INDEPENDENT EXPERT ADVISORY PANEL FOR MINING

MOOLARBEN COAL COMPLEX UG4 EXTRACTION PLAN FOR LONGWALLS 409-414 (MP05_0117)

15 AUGUST 2025

ADVICE NO: IEAPM 202508-01

Figure 11: Moolarben far-field movement database (*source: MSEC, 2024*)

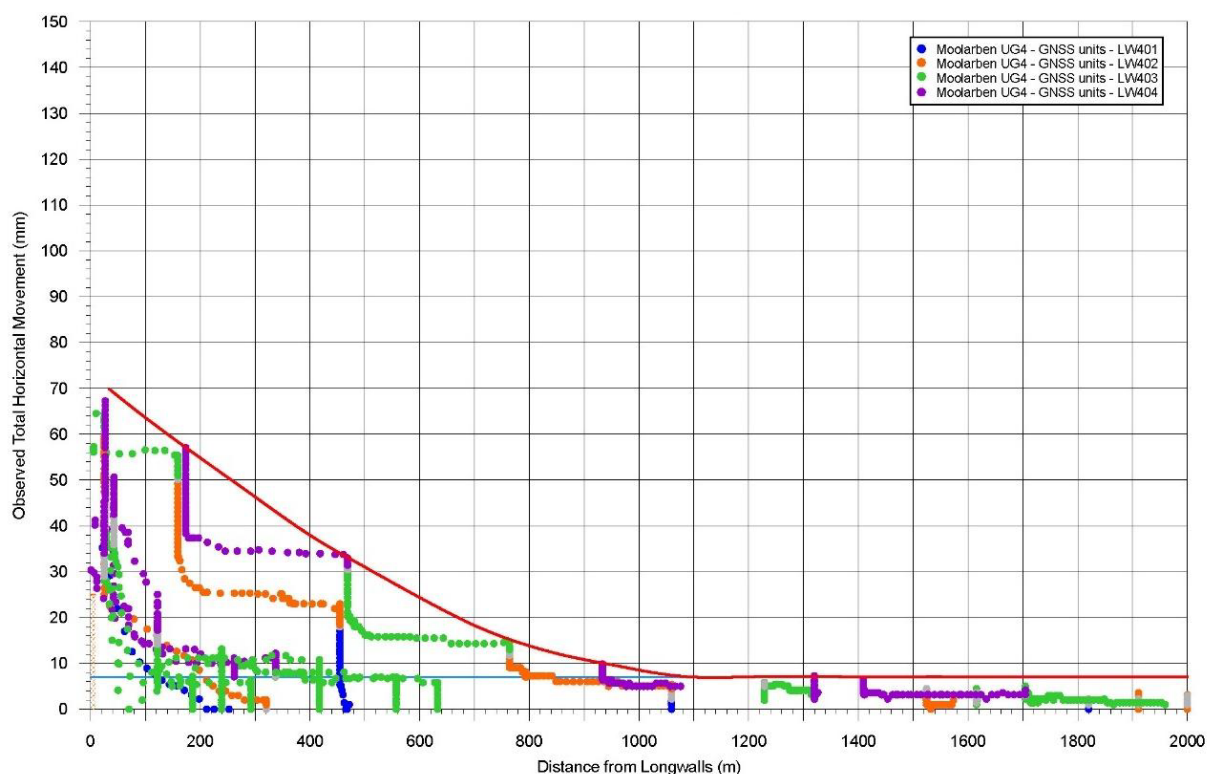
These measured results indicate a maximum value for far-field movements of 35mm at a set-back distance of 450m (corresponding to the closest Corner Gorge proximity) and approximately 21mm at 645m (the closest Drip proximity).

This database is being continually updated and the use of any parameters derived from it in the management plans should also be updated accordingly.

One of the recommendations by the Panel during discussions with Moolarben was to use the proximity of each of the initial panels to The Drip, to determine a lower level of far-field movement for the greater offset distances involved, by comparison with the predicted far-field movement indicated by the Figure 11 database. This would provide a useful incremental system of early warning for evaluating the reliability of the far-field distance prediction values and hence the overall subsidence model.

Figure 12: Location of heritage site S1MC287 (source: MSEC, 2024)

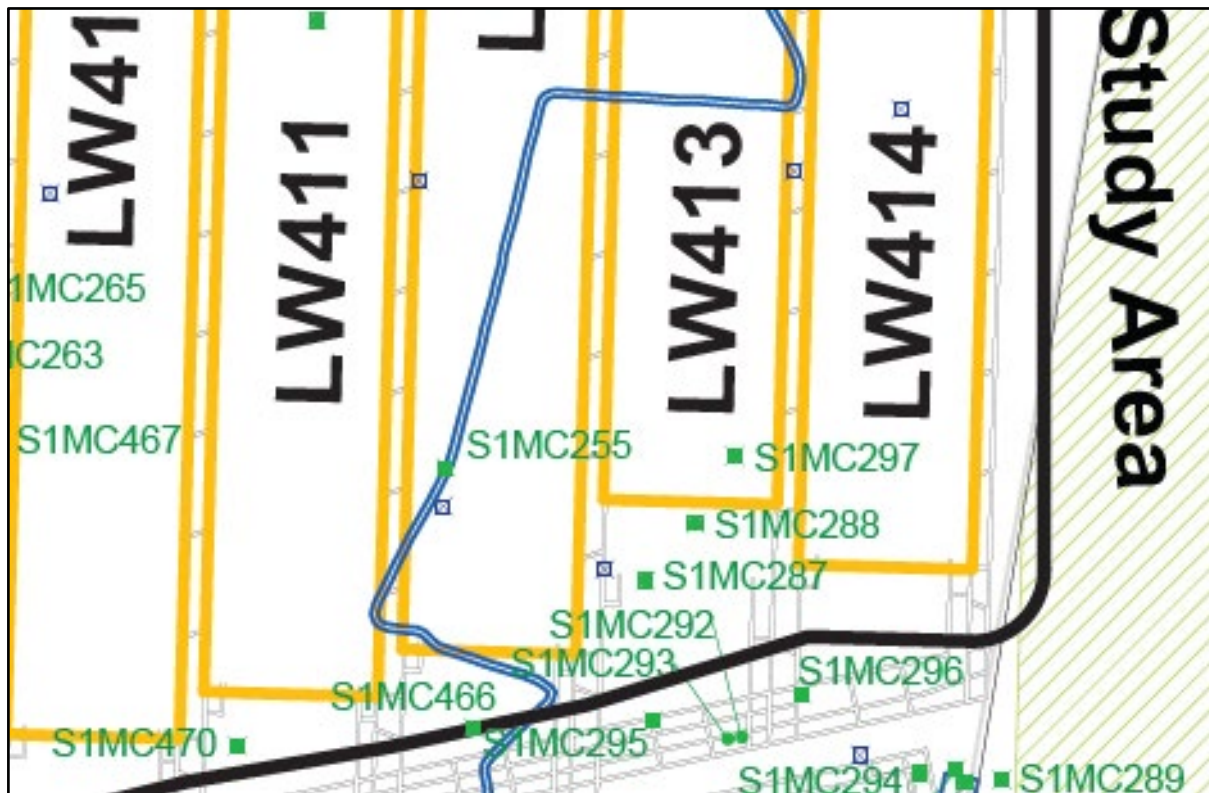
Site SM1C287 is specifically noted in the request for advice provided by the Department to the Panel. This site is located within the region of Cliff Line 3 (CL3) – beyond the southern finish line position of LW413 in a position that is also outside the Study Area boundary (as a result of LW413 being shortened to avoid damage to this cliff line), although the boundary shown on the plans does not accurately reflect this change.

The Panel is satisfied that this site should not incur any significant adverse impact, in accordance with the performance measures of low likelihood of damage. However, it is important that the monitoring program includes regular monitoring of this location – both with the approach of the adjacent LW412 and also LW413 and LW414.

Figure 13: Estimated saturated thickness of the Triassic sandstone strata as at December 2024 showing progressive dewatering above the current UG4 mined panels (*Source: Figure 2.1 from AGE 2025*)

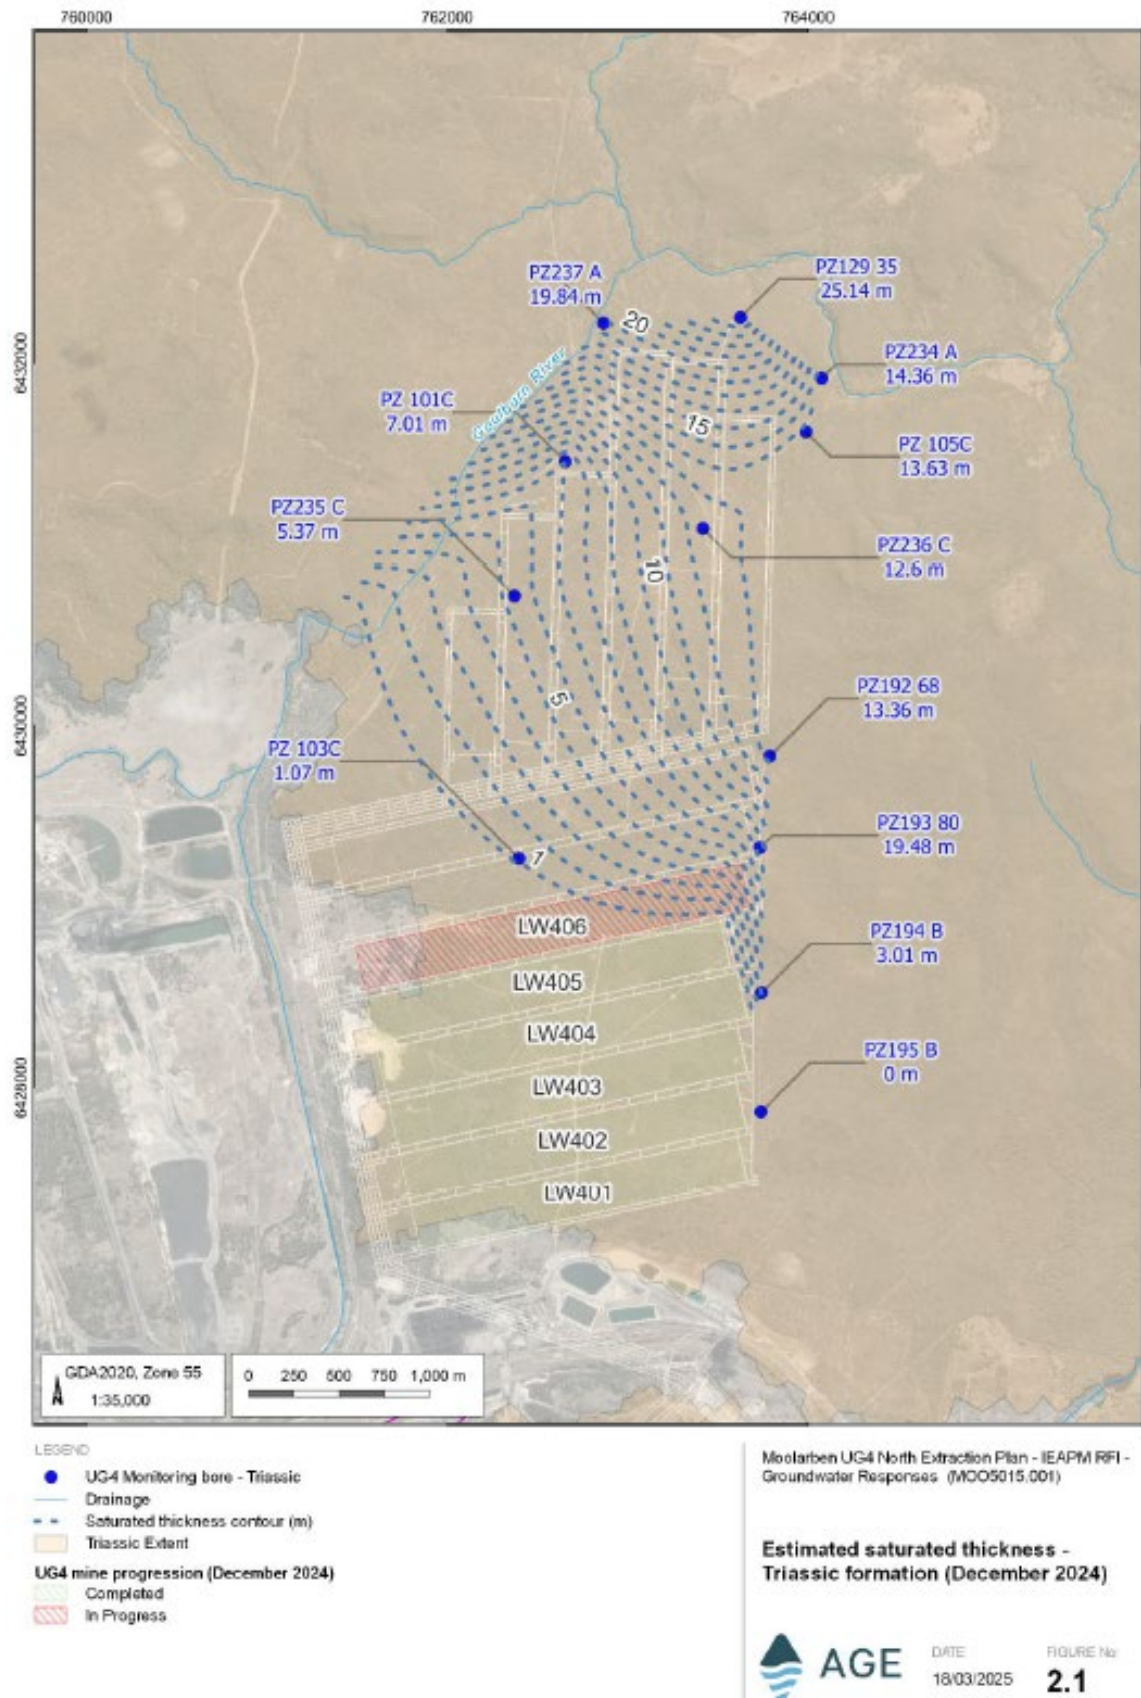
The Panel largely agrees with the updated conceptual model presented in section 4.5 of AGE (2024), with the exception that:

- There is evidence of extensive groundwater drawdown occurring within the Triassic sandstone aquifer and regional water table south of the Goulburn River.
- There is insufficient evidence that seepage at the base of The Drip is not regional water table controlled.

Figure 15: Groundwater and Cease to Flow Reduced Levels at PZ237 and SW02 (upstream of The Drip)

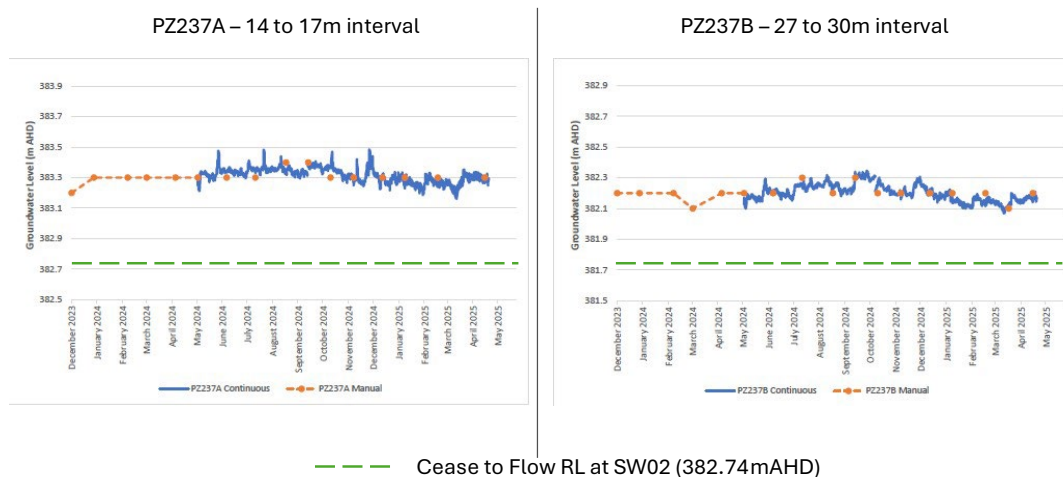
The very recent water level trend at the PZ234A site indicates that the regional water table is declining and that the slightly deeper zone in the Triassic sandstone aquifer (PZ234B) may in fact now be below river level.

The available monitoring data suggests there is reasonable connectivity between the regional water table in the Triassic sandstone and water levels in the Goulburn River. The model predictions for the baseflow contribution to the Goulburn River in 2025 across the whole model domain (for all approved mining) is of the order of 325 ML/year (Figure 5.20 in AGE 2024). This is predicted to reduce to 310 ML/year by 2036. This volume has not been segmented into the likely contribution and predicted loss between stream gauges SW2 and SW22.

Figure 17: Existing and proposed monitoring bore network (Source: Figure 7.1 from AGE 2024)

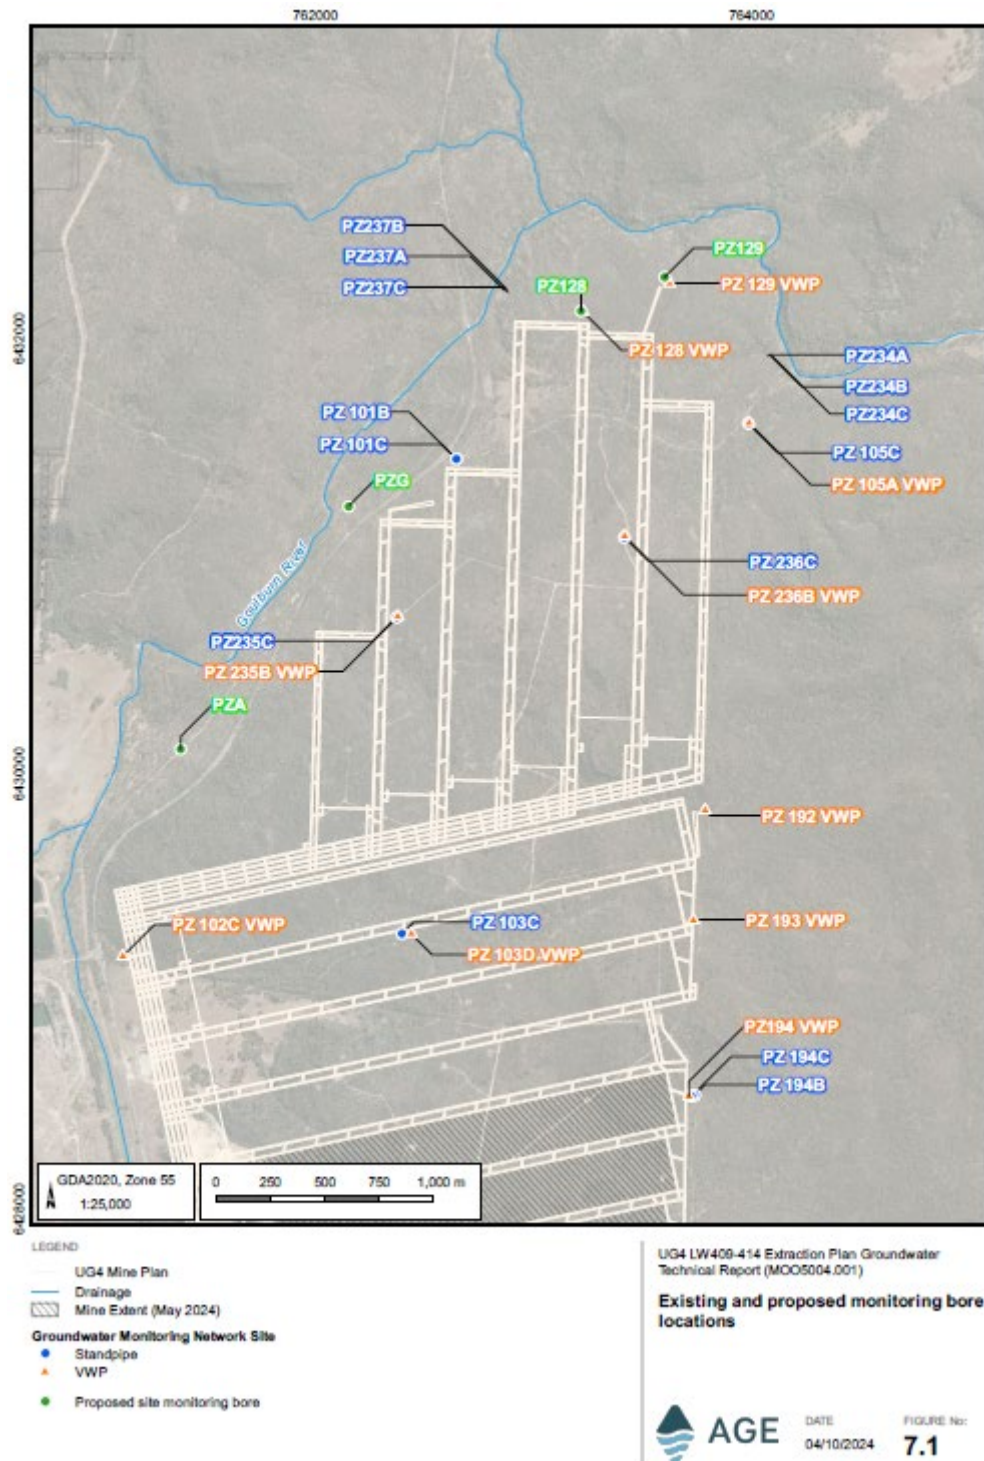
However additional groundwater monitoring is required north of the Goulburn River. MCO has committed to installing monitoring bores immediately north of The Drip to confirm the nature of the aquifer zones and to monitor water levels within the Triassic sandstone. One site will be a VWP piezometer with an unknown number of sensors, the other site is described as an ‘open hole’ standpipe. Indicative locations are shown in Figure 18 (AGE 2025). The location closest to The Drip at the slightly lower elevation is preferred for the standpipe location.

The Panel recommends that two (nested) standpipes be completed at the standpipe location rather than a single ‘open hole’ completion to prove that the first water cut is perched groundwater and that the deeper water cut at river level represents the regional water table. An ‘open hole’ completion is likely to drain perched groundwater and could have the unintended consequence of draining seepage flows that would have otherwise migrated towards The Drip. The Panel strongly recommends against an open hole completion for this monitoring site.

Figure 18: Indicative monitoring bore locations proposed north of The Drip

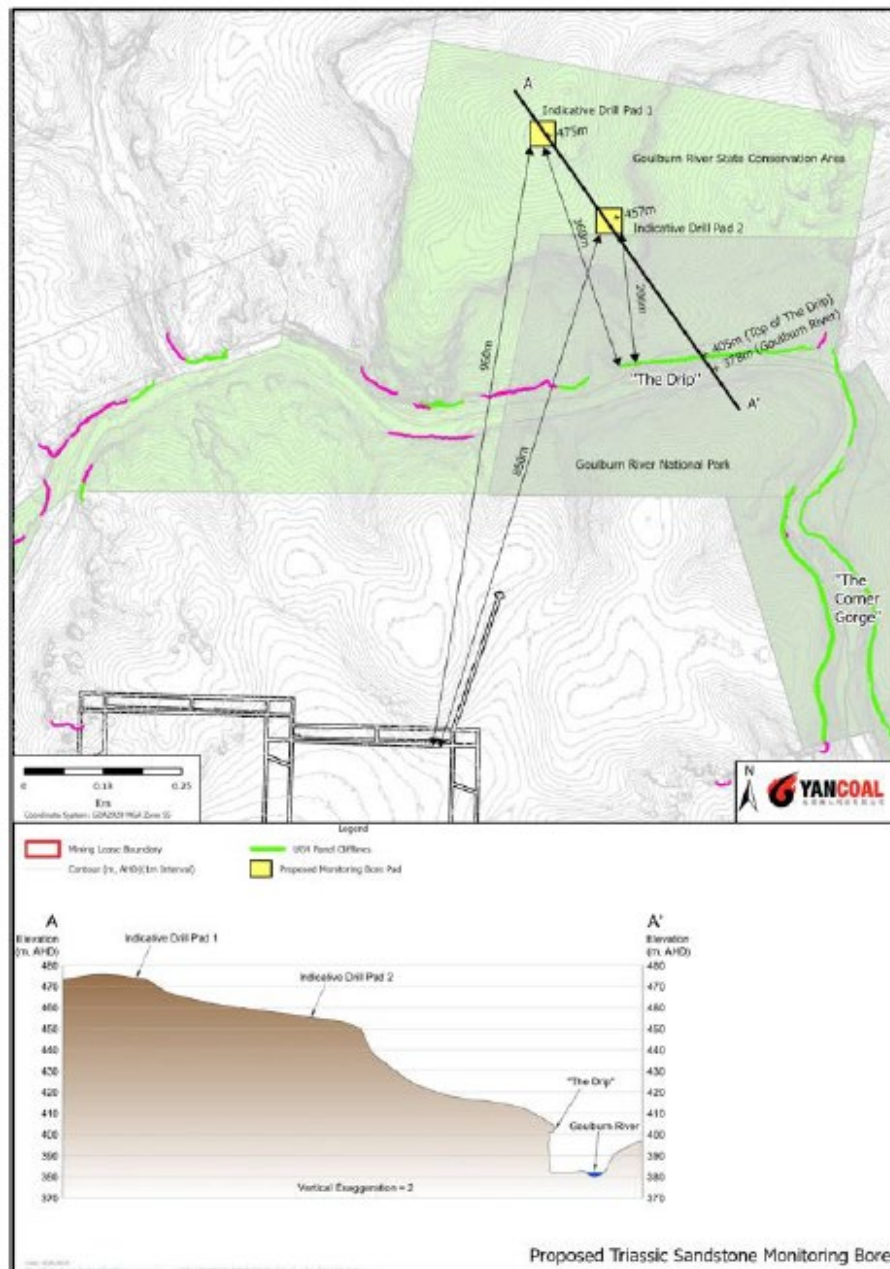
As a part of the development of the design and installation procedures for these sites the Panel recommends that a risk assessment is undertaken to minimise the likelihood of adverse impacts on the groundwater system and The Drip.

When the groundwater monitoring network is complete it is expected to provide an appropriate level of data to monitor the groundwater impacts arising from the extraction of LW409 to LW414. The early completion of the new sites in Q3 2025 and commencement of baseline monitoring is supported by the Panel.

Figure 21: Maximum predicted cumulative drawdown in the Triassic Sandstone local to the Goulburn River in the Triassic sandstone (Lithic) until end of mining (2038) [reproduced from Figure 5.15 (AGE 2024)].

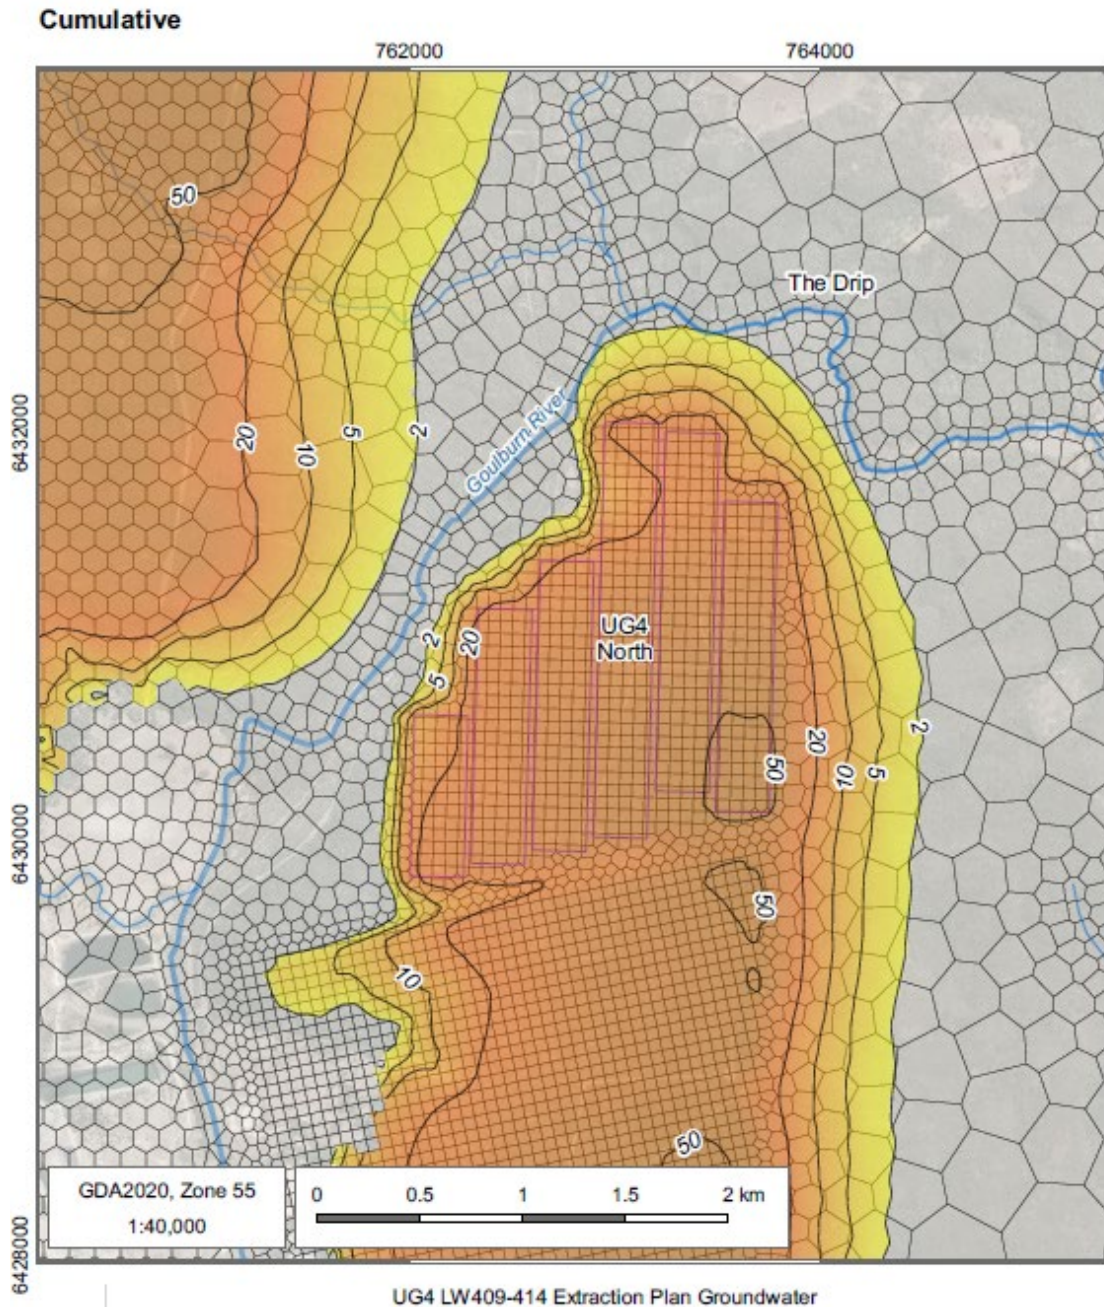
First, the recent impacts on the Triassic sandstone overlying LW409 to LW414 arising from current mining of LW401 to LW408 are controlled in part by the dewatering of the Triassic sandstone above and adjacent to the mine workings. This is likely to have caused a more muted lateral groundwater response to mining at distance from the workings compared to a condition where full desaturation does not occur adjacent to the mined area. This control on the lateral extent of groundwater table decline may be less pronounced for LW409 to LW414.

Second, if a higher vertical connectivity through the Permian overburden above the Ulan Seam to the overlying Triassic sandstone exists relative to the modelled connectivity, then the timescales for observations of impacts from this groundwater pathway may not yet be visible but could have longer term implications for water table decline in the vicinity of The Drip.

It appears from the current modelling predictions that if the drawdown beneath The Drip exceeds the current predictions, the exceedance would occur even without the planned mining of the current longwalls. This is most easily seen from Figure 5.15 of AGE (2024), reproduced in part in Figure 21 below, which shows the encroachment of drawdowns from the UCC to the west as well as encroachment of drawdowns from the south on the Triassic sandstone beneath the Goulburn River.
